Re-worked UltraLinks

How to identify a re-worked device

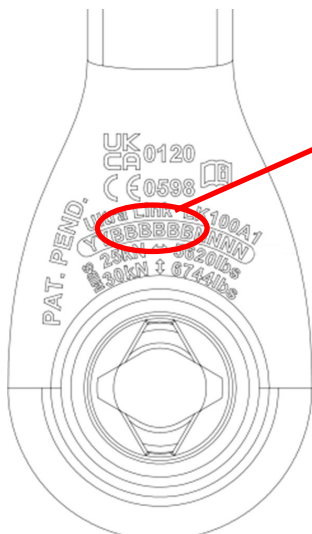
All recalled UltraLink devices from the affected batches, which have been re-worked in our factory, have been Dot-matrix marked with a letter 'A'.

The re-work marking is located on the side of the guard which surrounds the spring-loaded button. This 'A' marking enables users and PPE Inspectors to identify that a device that falls within the recalled batch range, has undergone rework, and has been deemed suitable for return to service.

Any devices bearing serial numbers that fall within the range of affected (recalled) devices, but **DO NOT** bear the official re-work marking, must be **removed from service IMMEDIATELY**
